Request to Verify Supply Pressure of DKL7440 Chiller Cooling Water

Report of typographical error

■ Correction details

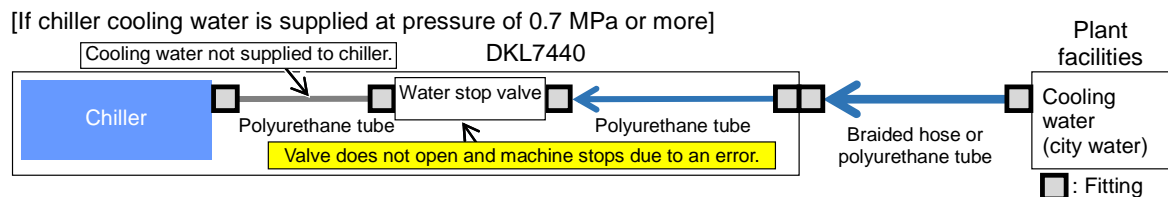
There was a typographical error relating to the supply pressure of the DKL7440 chiller cooling water in the Installation Manual and KABRA!zen Safety Manual. We would like to ask you to correct it after verifying the details.

Chiller cooling water: Supplied pressure	Correct	0.2 to 0.4 MPa
	Incorrect	1 MPa or less

If chiller cooling water is supplied at a pressure of 0.7 MPa or more, there is a risk that the water stop valve in the supply water path from the facility side to the chiller will no longer open. If the water stop valve does not open, cooling water will not be supplied to the chiller, and the machine will stop due to a chiller temperature irregularity error.

In addition, there is a risk that supplying chiller cooling water at high pressure could cause the polyurethane tubes used for piping to break or come loose.

To prevent a negative impact on the water stop valve and polyurethane tubes, please verify the facility-side supply water pressure. If it is outside the correct pressure range above, adjust it to an appropriate pressure.
